Thrive Assisted Living Facility at Black Hill Site Plan No. 820160100

The Applicant is requesting to construct a 140-room assisted living facility, associated parking facility (61 parking spaces), lighting, and landscape on Lot 22 of the Black Hill mixed-use development. The subject property is 2.31 acres of land; developed under the TMX-2 Zone within the Germantown Employment Area Sector Plan.

Staff Recommendations: Approval with Conditions

Staff recommends approval of Site Plan No. 820160100. All site development elements shown on the latest electronic version as of the date of this Staff Report submitted via ePlans to the M-NCPPC are required except as modified by the following conditions.¹

TRUCK MANUVERING EXHIBIT

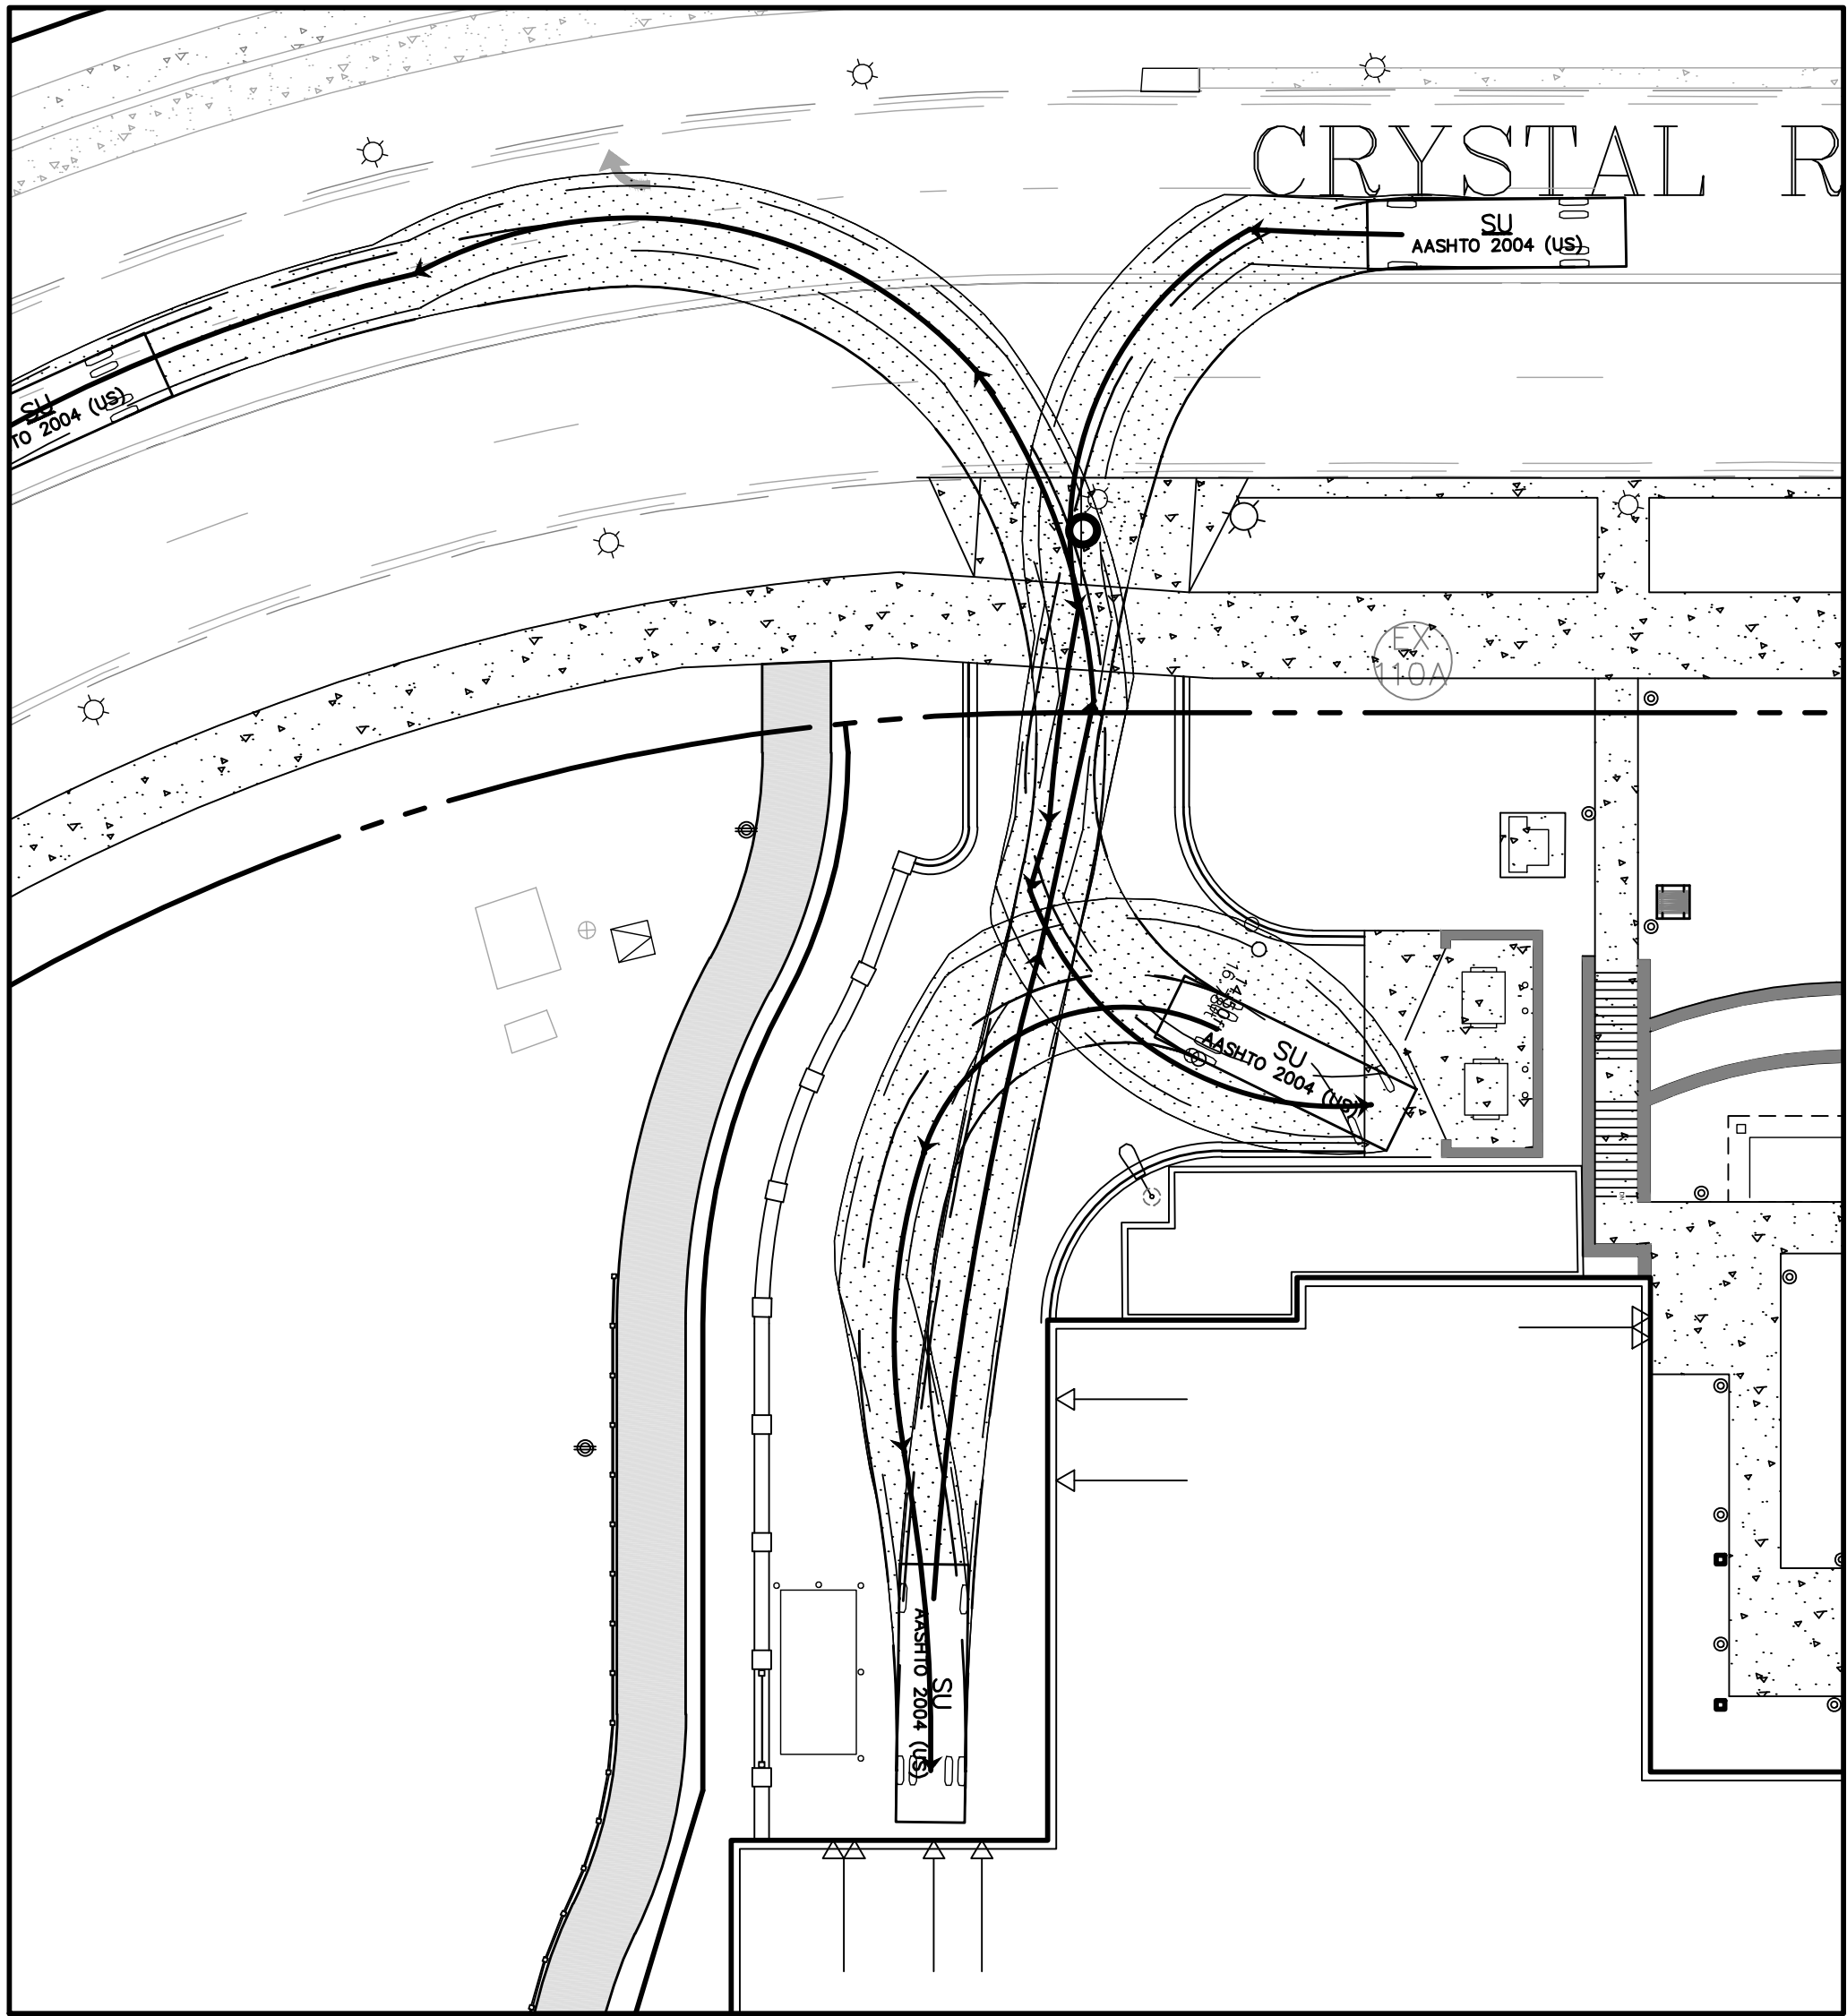
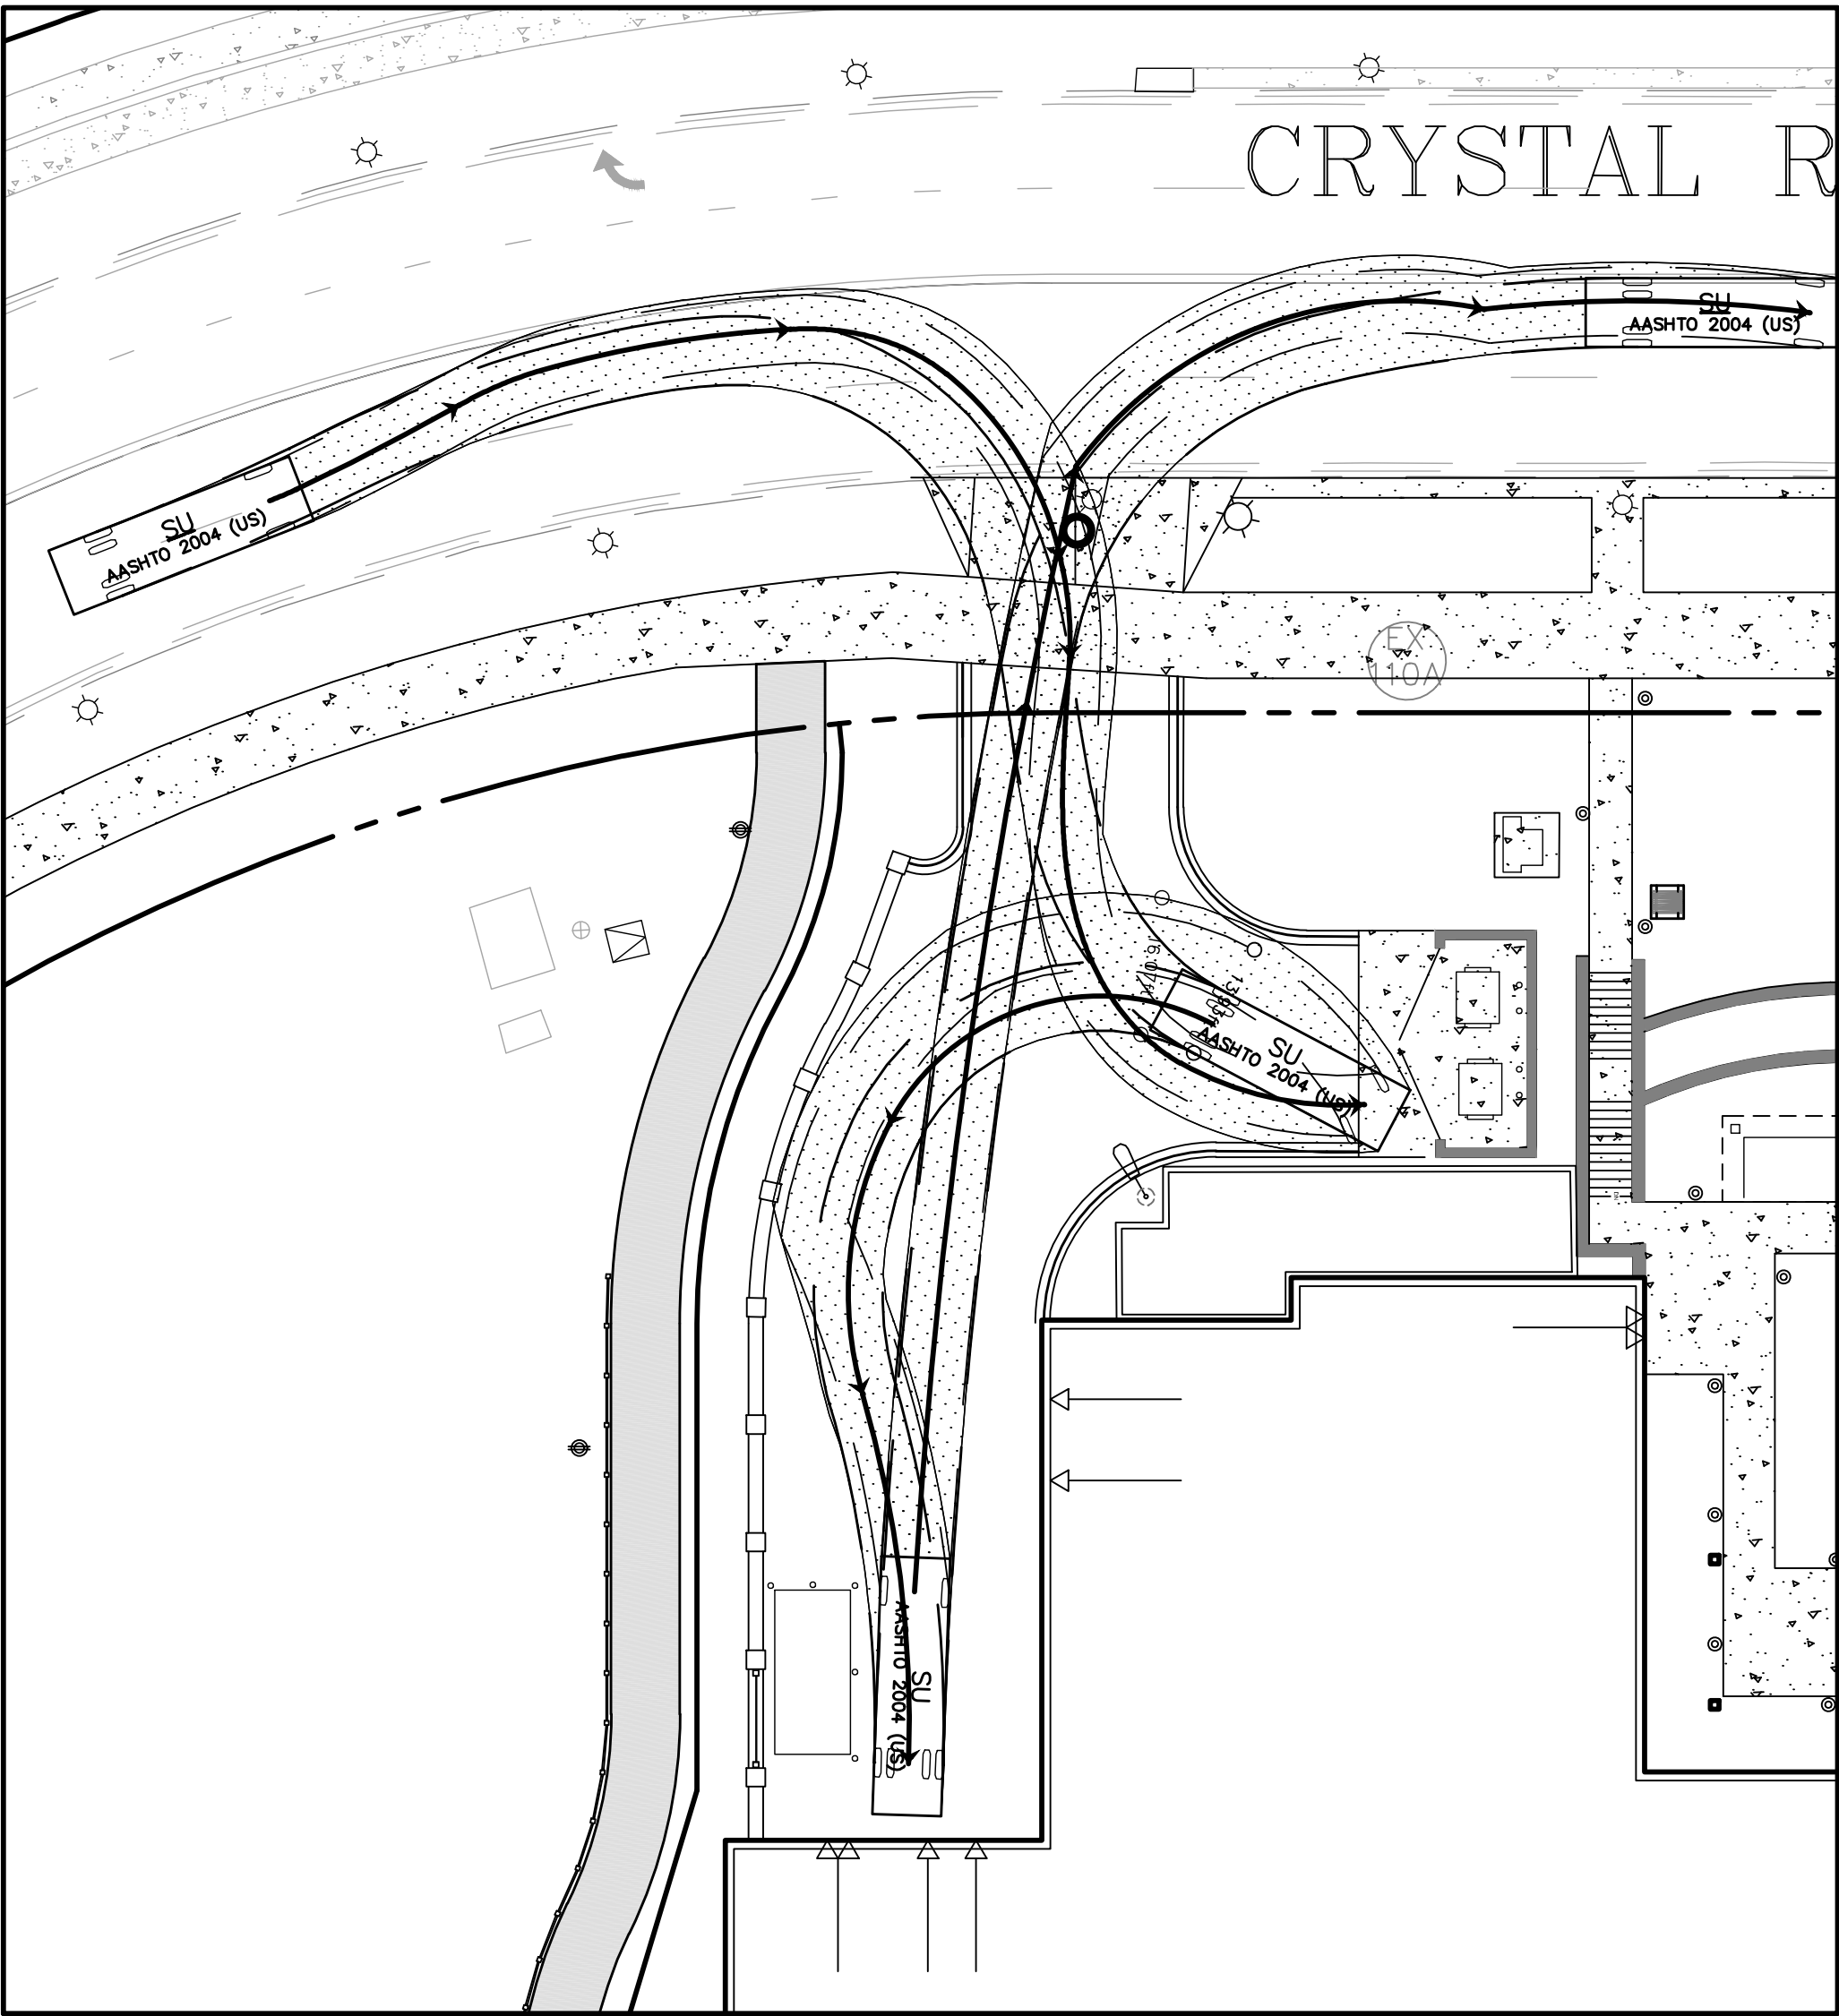
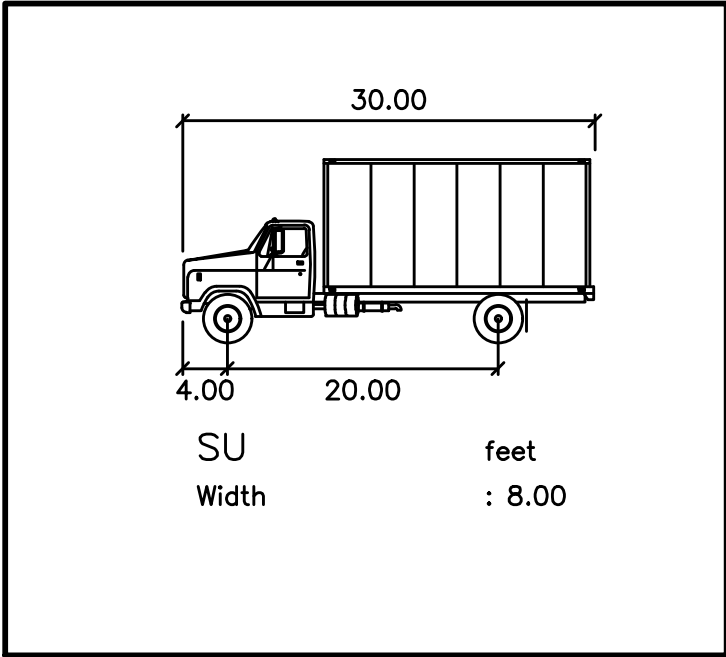
MCDOT has reviewed and approved the turning movements from the service driveway onto Crystal Rock Drive. Staff finds that the service driveway and the access from the surface parking facility are safe, adequate and efficient.
